DEMOLITION FLOOR PLANS

ST. TAMMANY PARISH ADMIN. COMPLEX
520 OLD SPANISH TRAIL
SLIDELL, LOUISIANA

RENOVATE OFFICE BUILDING

D-4

4TH FLOOR
DEMOLITION PLAN
SCALE: 1/8" = 1'-0"

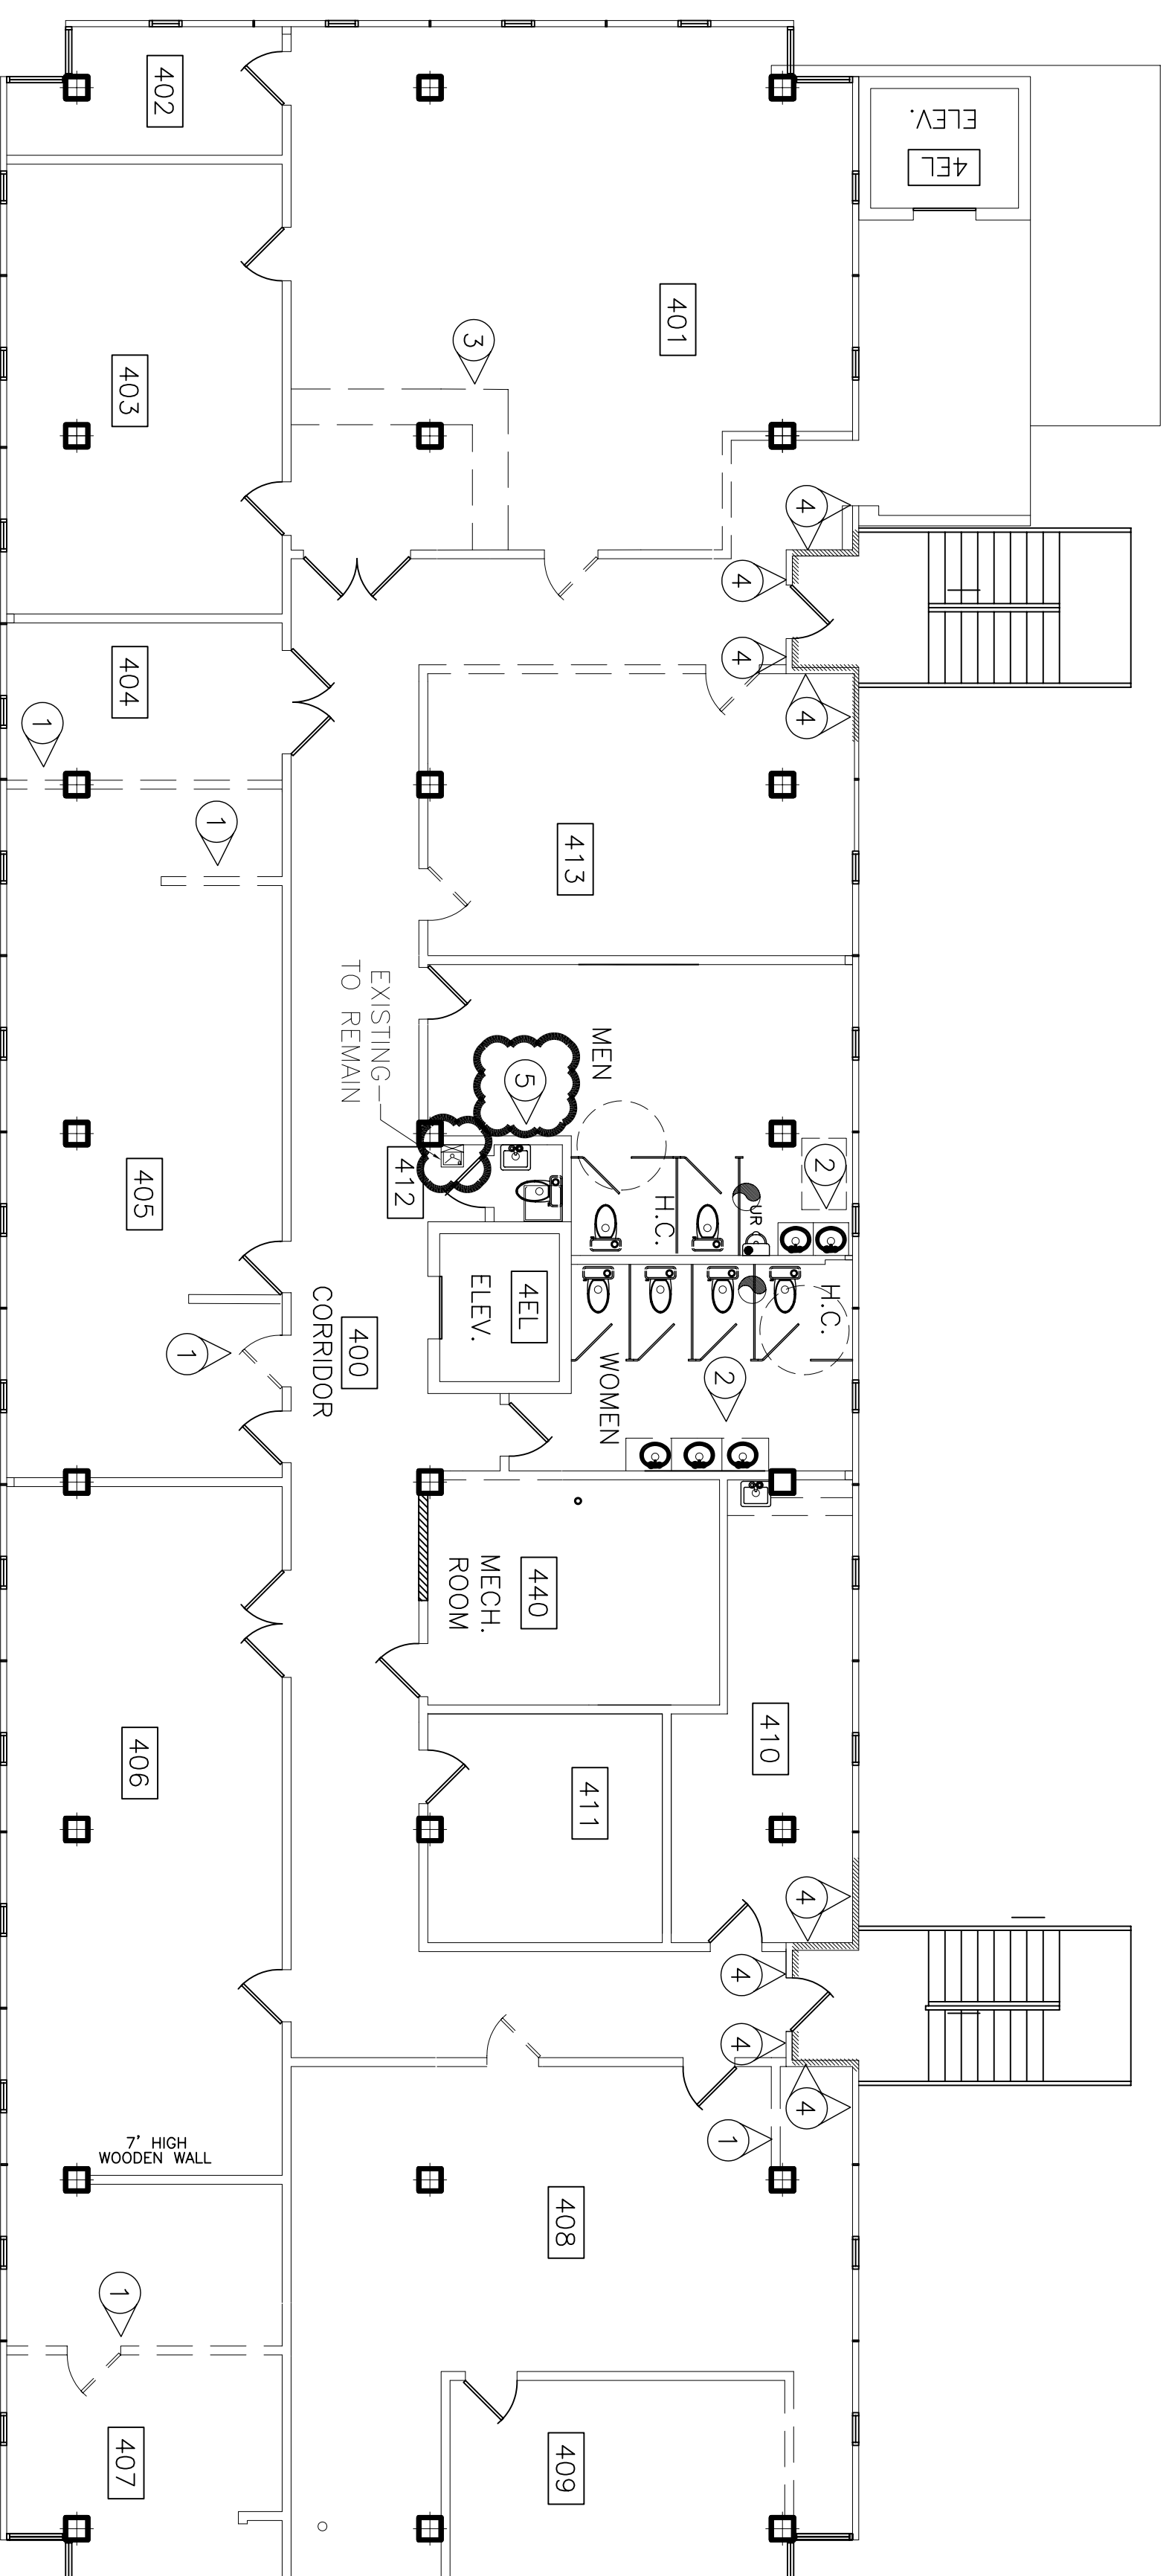
- 1. REMOVE EXISTING WALLS & DOORS.
- 2. REMOVE ALL EXISTING LAVATORIES; UNUSABLE WATER CLOSETS, URINALS & PARTITIONS. PROTECT PIPING FOR RENOVATIONS
- 3. REMOVE EXISTING COUNTER.
- 4. REMOVE WALLS IN THESE AREAS FOR INSTALLATION OF 1 HR. FIREWALL.
- 5. REMOVE EXISTING LAVATORY AND WATER CLOSET IN ROOM 412.

= ADDENDUM 3 CHANGE
